HAY CREEK VALLEY

PRELIMINARY SITE DEVELOPMENT PLAN

HAY CREEK VALLEY SUBDIVISION
PRELIMINARY SITE DEVELOPMENT PLAN
EL PASO COUNTY, CO
01/20/2023

V1_Preliminary Plan Drawings.pdf Markup Summary 2-28-2023

TS01

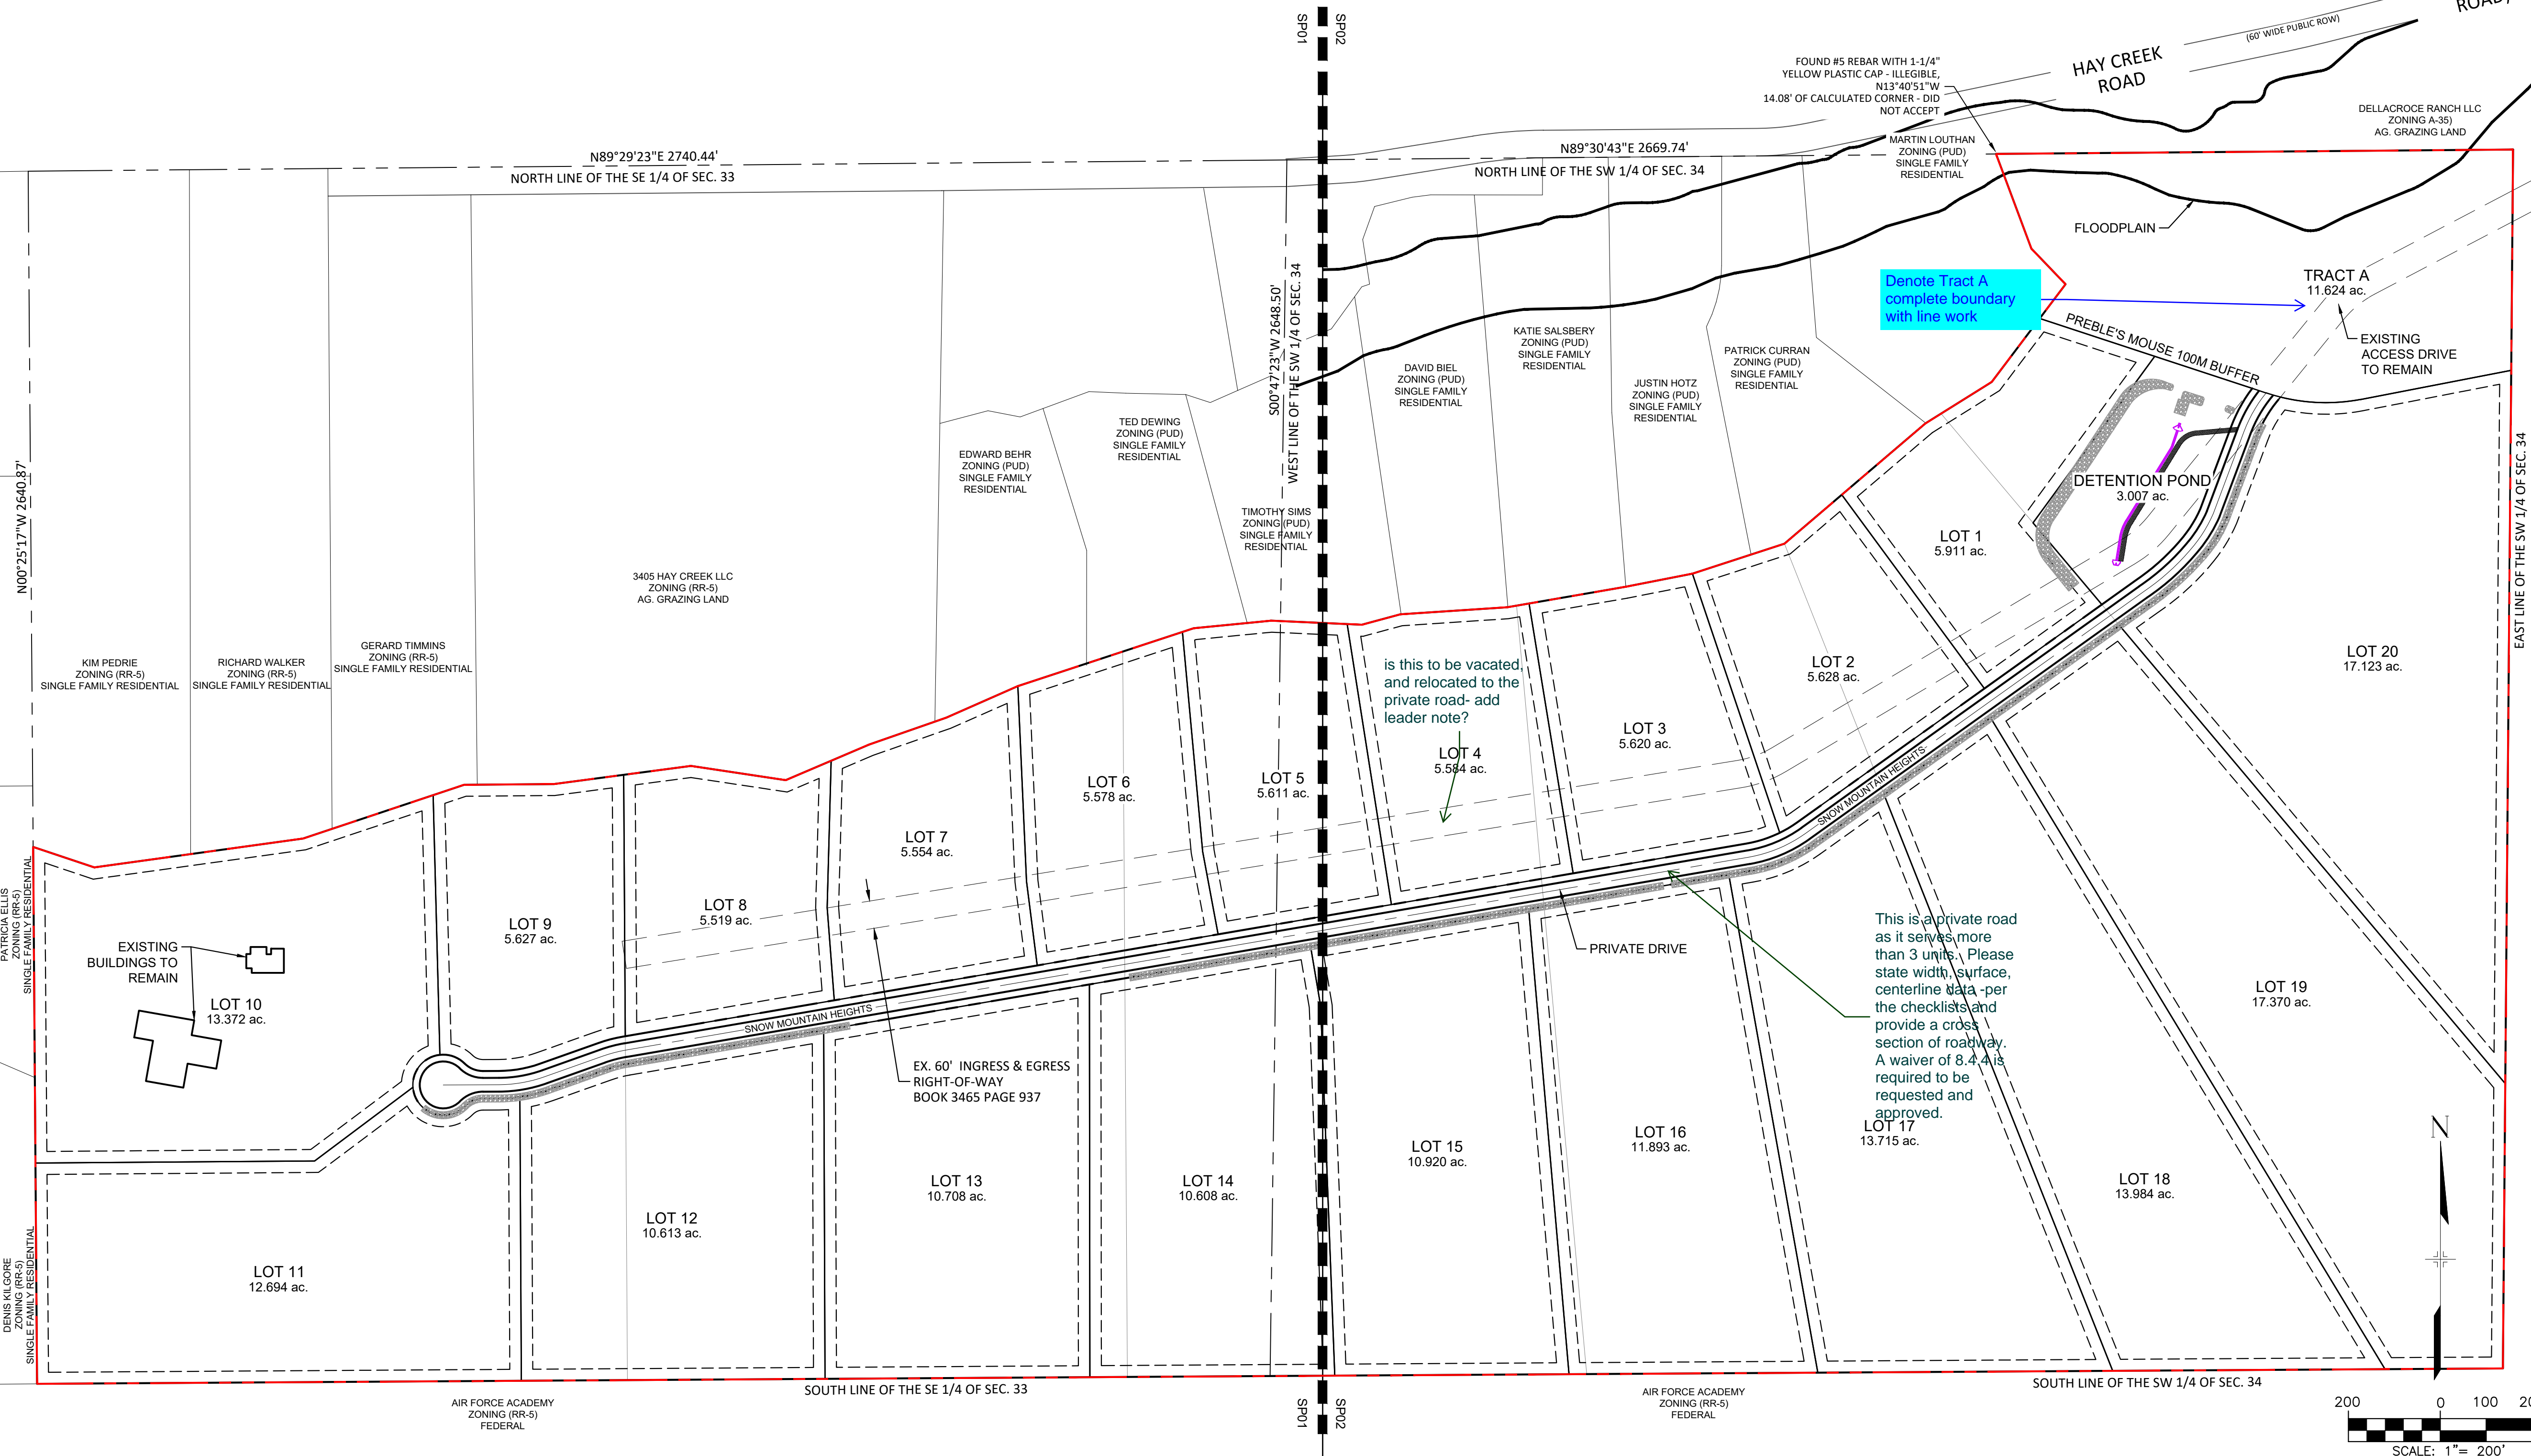
this is a preliminary plan not a site dev plan. see checklists.

vicinity map first sheet

is sheet 2 supposed to be sheet 1 here? This sheet appears to be showing adjacent property info which could be added to the detailed sheets.

Provide a table that breaks down lots, open space and detention pond tracts and roads by acreage

this is not correct- private roads

Denote Tract A complete boundary with line work

This is a private road as it serves more than 3 units. Please state width, surface, centerline data per the checklists and provide a cross section of roadway. A waiver of 8.4 is required to be requested and approved.

GN01

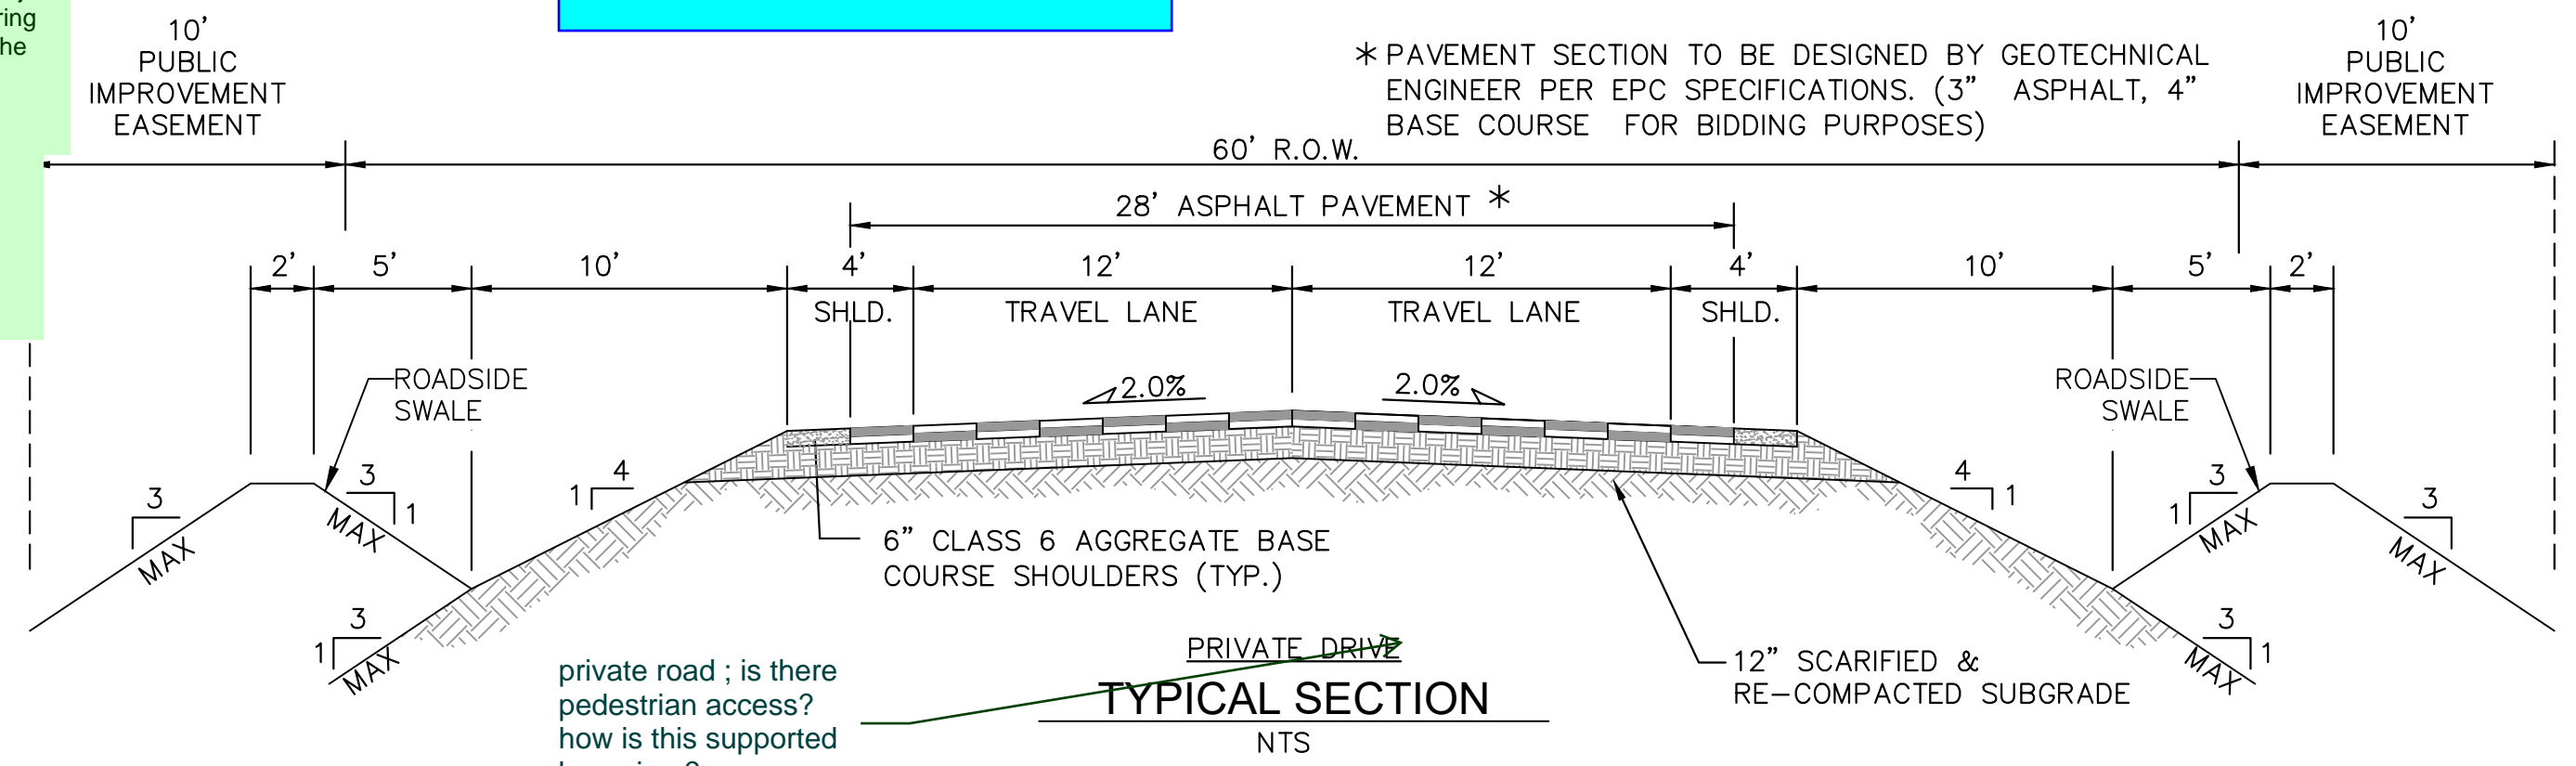
water and ww reprints not submitted. Prelim notes need to identify water and wastewater deferred to plat

This conflicts with the LOI which request participation in PID #2

this will be determined at final plat when review of road design is completed.

revise and customize for the lots

tracts are to be owned and maintained by?

Denote the road classification i.e rural local Road (PVT)
Add design and posted speed

private road ; is there pedestrian access? how is this supported by waiver?

SP01

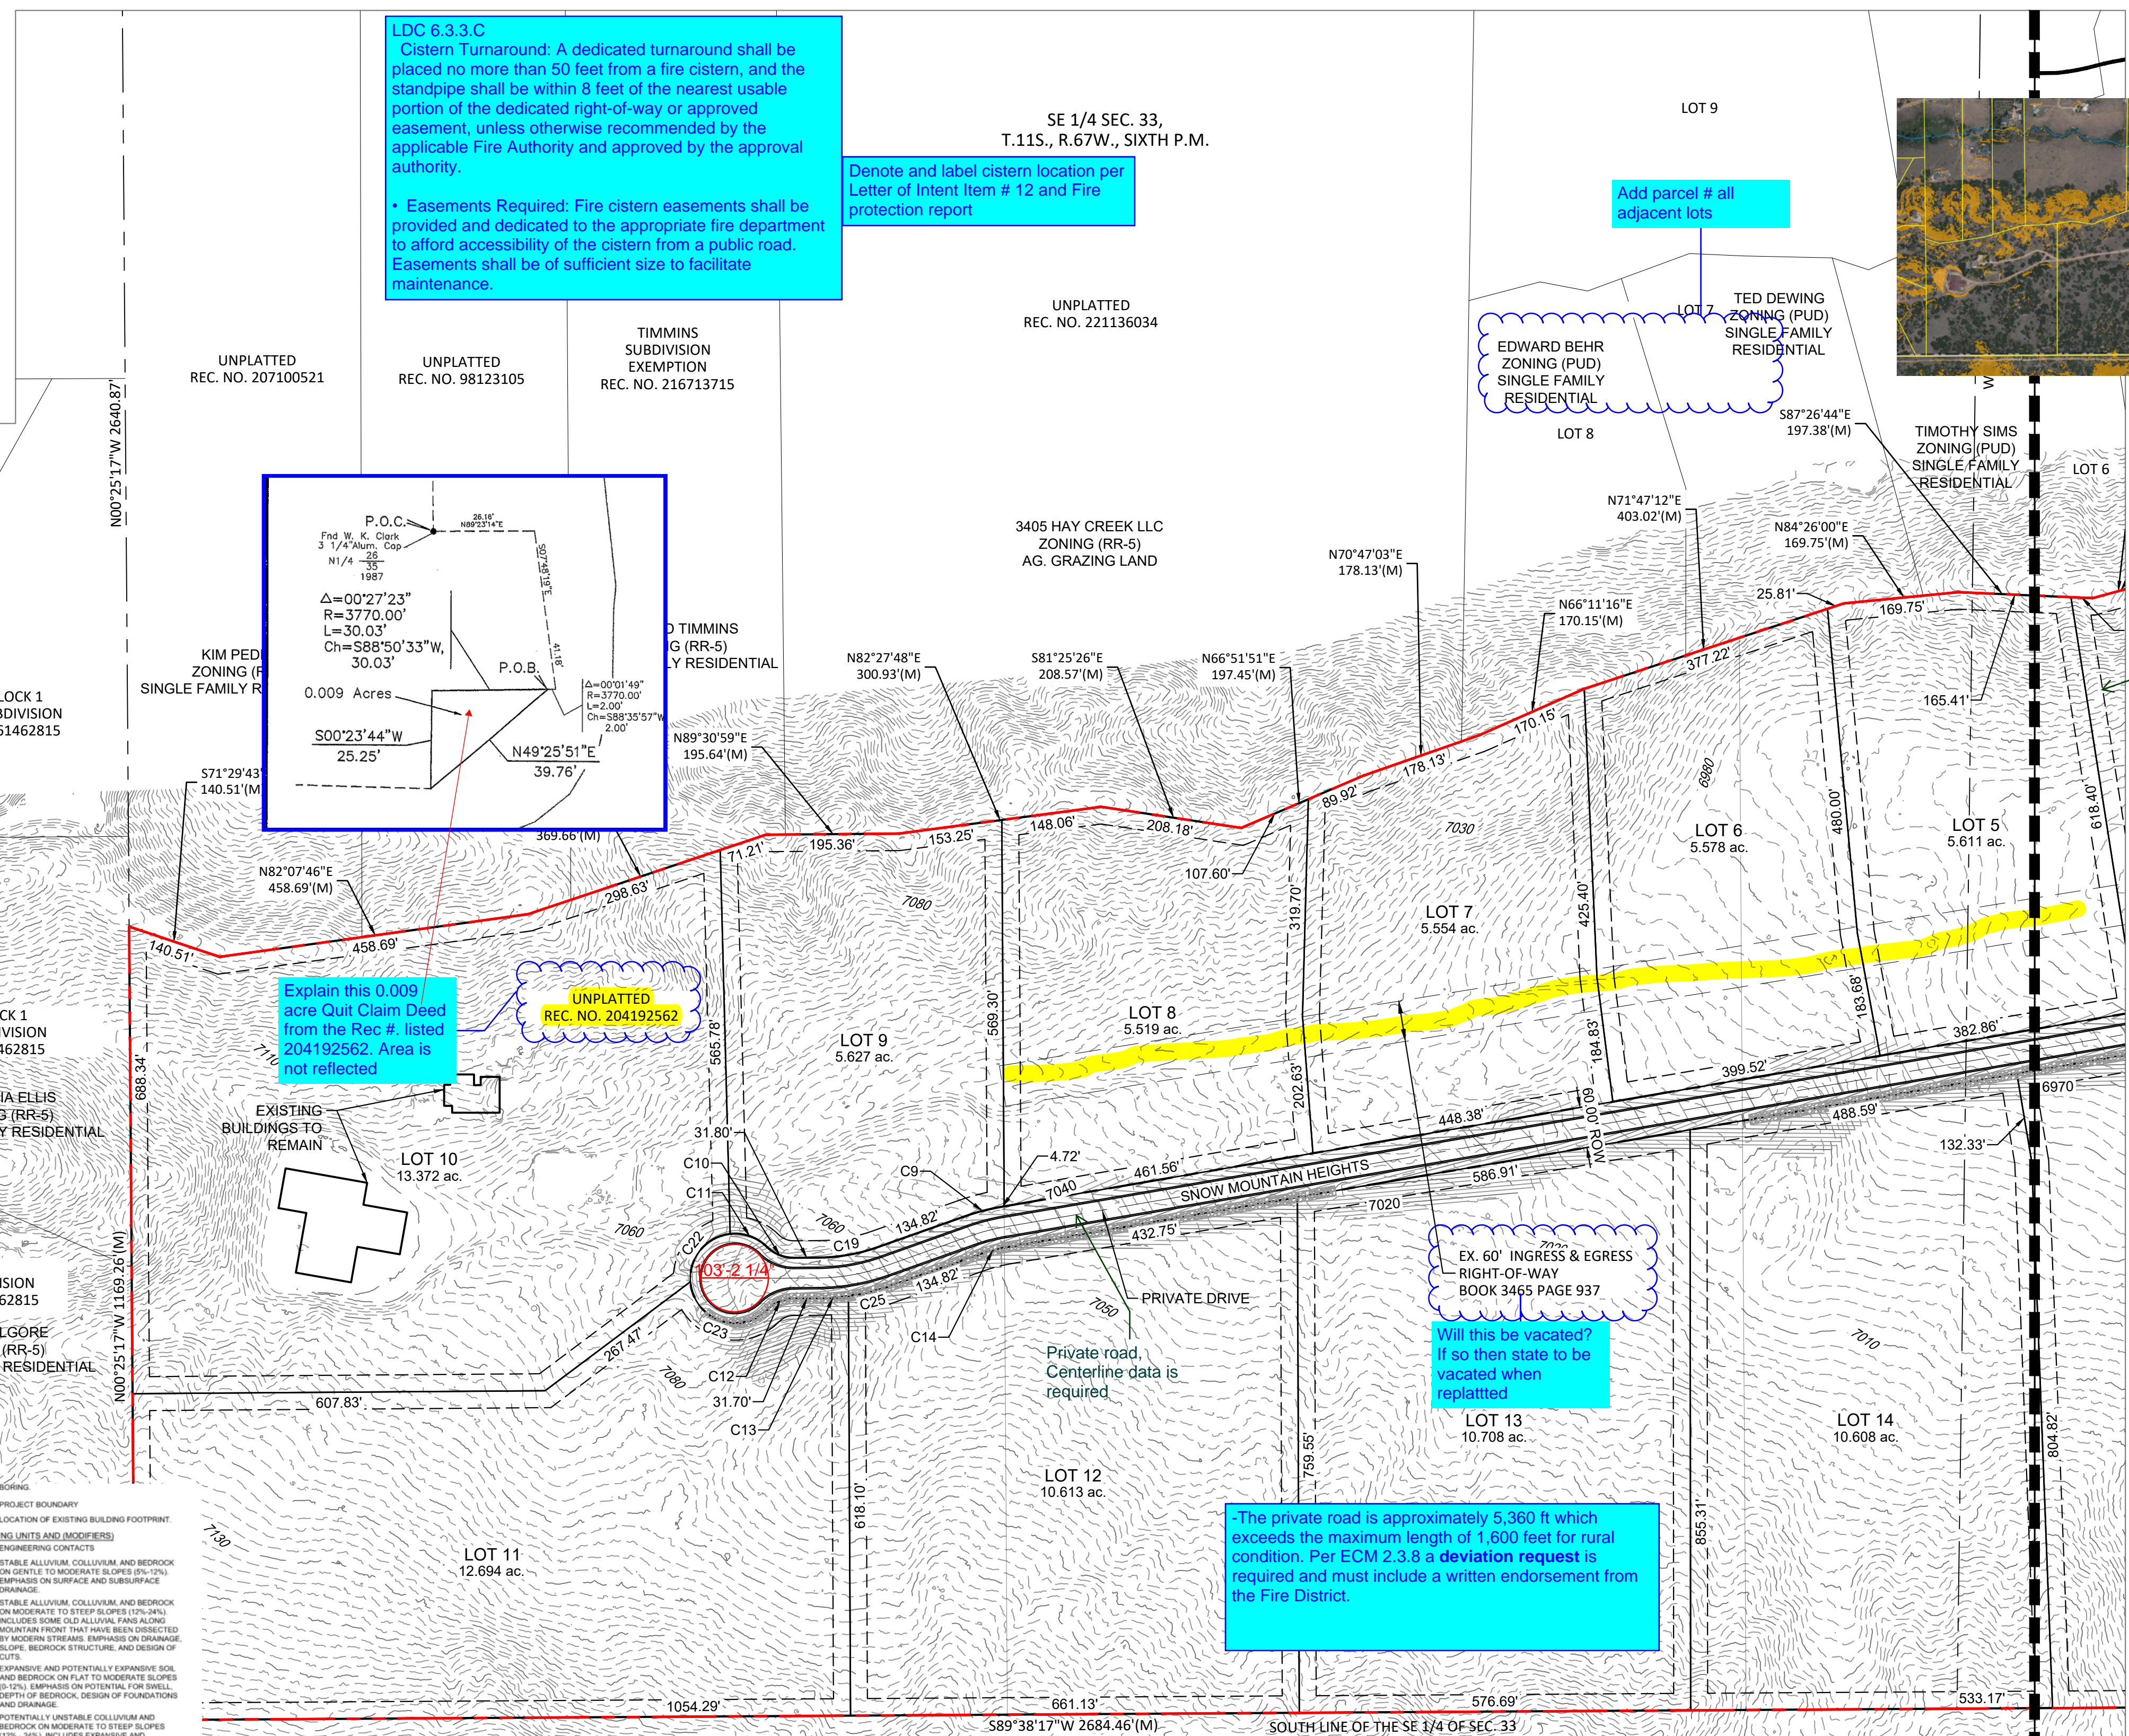
Denote and label cistern location per Letter of Intent Item # 12 and Fire protection report

Add parcel # all adjacent lots

label the no build areas please; anything w slope 30% higher; rockfall; unstable slopes etc

these (slopes and floodplain areas) should be included as depicted no build areas on plan and reflected in the notes specific to the lots as should the bedrock and drain constraints

Please contact USAFA to determine if additional buffer is requested and/or notes

not shown

SP02

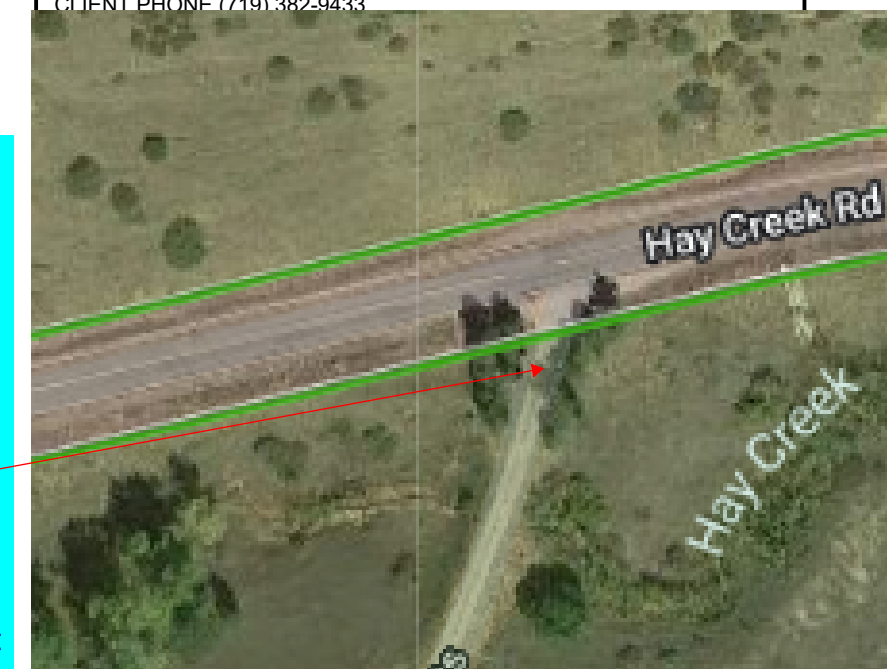
depict Cistern tract, and add note size, location, and M of Cistern
 Are there no rock outcroppings on the site to be protected?

Per LDC 8.4.2.B.1 Approved Base Flood Elevation (BFE) and 100yr boundary shall be shown on the Plat. Please show FEMA approved BFE with new boundary and reference case #

Adjust view to include intersection

Label this access easement or ROW by Book or Rec #

Show private road continuation all the way to Hay Creek Rd to include intersection. Provide curve and intersection details. Intersection will require 90 degree realignment. This road section will need to be paved.

Intersection alignment must meet criteria (ECM 2.3.7.C.2). Should be at 90 +/- 10 degrees. Traffic Impact Study to verify sight distance at the intersection especially to the east.

Denote Tract A boundary to include detention pond and add required easement around pond

Label this easement and add note if to be vacated

Add parcel # for all adjacent lots

Are you incorporating the recommendation in the Wildland fire report in regard to home placement, (highlighted in yellow in report) road turn arounds -600-feet? slope avoidance? I didnt see that in the notes or reflected in no build areas or road plan?

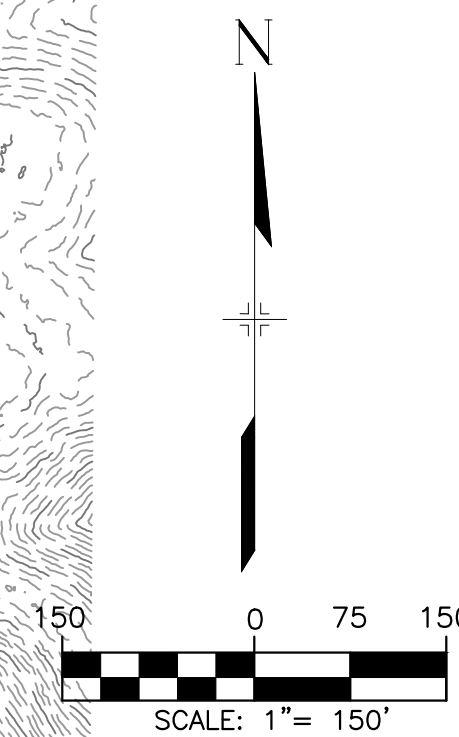
Note all driveway entrances from the Private road must meet grade limits per LDC 6.3.3.C.3 Grading plan and Road CDs must ensure lots do not have driveway slopes exceeding 10% and driveway entrances do not exceed 4% for the first 20ft. Transition grades are 6% maximum for a distance of 50 feet minimum.
